Proposal for the 10 series of amendments to UN Regulation No. 16 (Safety-belts) *

Submitted by the expert from Japan

The text reproduced below was prepared by the expert from Japan aiming to add an editorial corrections and clarify the transitional provisions to the working document ECE/TRANS/WP.29/GRSP/2023/32. The modifications to the working document by this document are marked in red.

Model A
(See paragraph 5.2.4. of this Regulation)

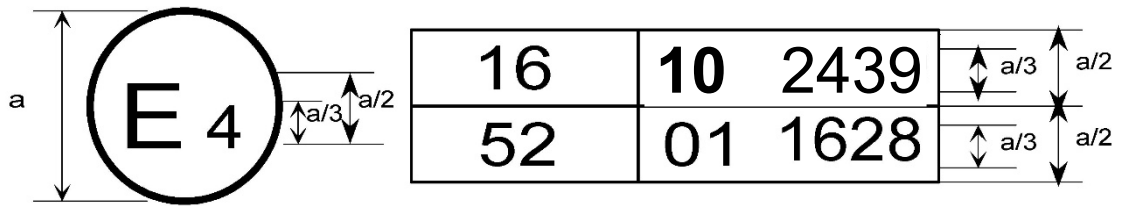
The above...amended by the **10** series of amendments.

Figure 1

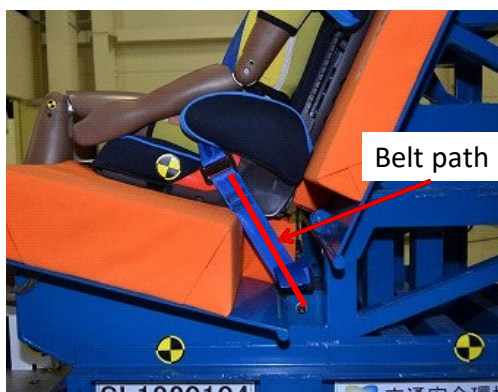
1. The strap's paths between the effective safety-belt anchorage and the buckle are normally straight like the test bench specified in UN Regulation No. 129 (Figure 1). However, the strap's paths between the effective belt-anchorage and the buckle of some vehicles in the market are not straight and are curved along the cushion (Figure 2).

Figure 2

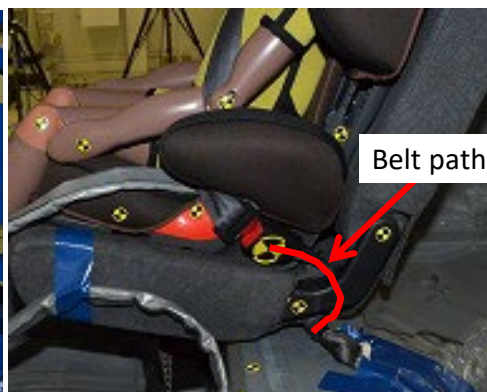
2. When the strap's paths between the effective belt anchorage and the buckle are not straight, the occupants may move significantly forward during a frontal impact accident. If an occupant is seated in the booster seat attached by ISOFIX, there are cases in which the seatbelt slips up to the neck and in which submarining occurs (referred to in GRSP-69-24). These phenomena would increase the risk of injuries to the neck and abdomen of a child occupant. In addition, the dummy chest injury increases. Figure 3 shows the relation between the amount of slack of the buckle strap and dummy 3 ms chest maximum acceleration for two types of CRS. When the slack of the buckle belt was 50 mm in left graph, the chest maximum acceleration approached UN Regulation No. 129 criteria in one CRS. When the slack of the buckle belt was around 80 mm in both graphs, the chest maximum acceleration exceeded the above-mentioned criteria.

- "8.2.3. **The requirement below relating to the strap between the buckle point and the effective belt anchorage is only applicable to the rear seating positions of M₁ category vehicles.**
- 8.2.3.1. **The difference between the actual strap length and the straight line distance between the point EA and Bd point shall be 80 mm or less.**
- The above requirements may be shown by the actual vehicle, parts, drawings, or 3D data at the manufacturer's discretion.**
- The correlation between actual vehicle and/or parts and the drawing or 3D data shall be demonstrated by the manufacturer.**
- 8.2.3.2. **The requirement of paragraph 8.2.3.1. shall not apply if any of the following conditions are satisfied;**
- (a) The safety-belt assembly is equipped with a Pre-loading device.**

- (b) The manufacturer demonstrates to the satisfaction of the Technical Service through the use of experimental data, simulation, or desktop strength calculations that the buckle strap assembly has the same performance as the requirement in point (c) below.
- (c) When the buckle strap assembly is tested using the method described in Annex 19 of this Regulation, the buckle point movement shall be no greater than 80 mm at a tensile load of 1,000 N +/-50 N.”

Figure 3

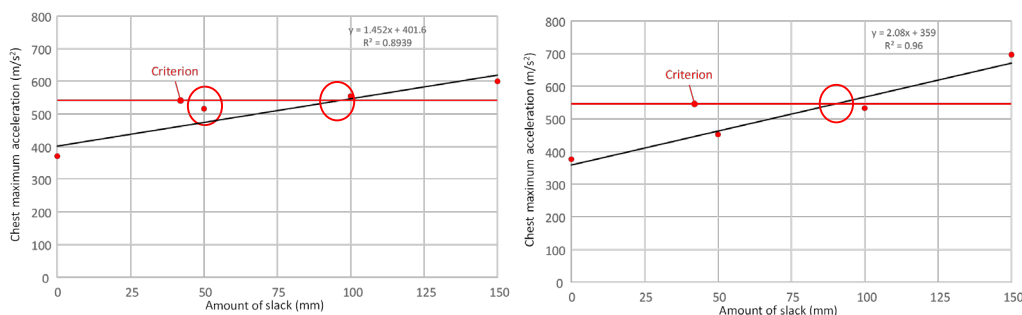
3. The slack of the buckle belt makes the passenger's excursion larger, negatively affecting the safety of the occupant (referred to in GRSP-70-32).

4. Therefore, we propose to limit the slack of the buckle-belt.
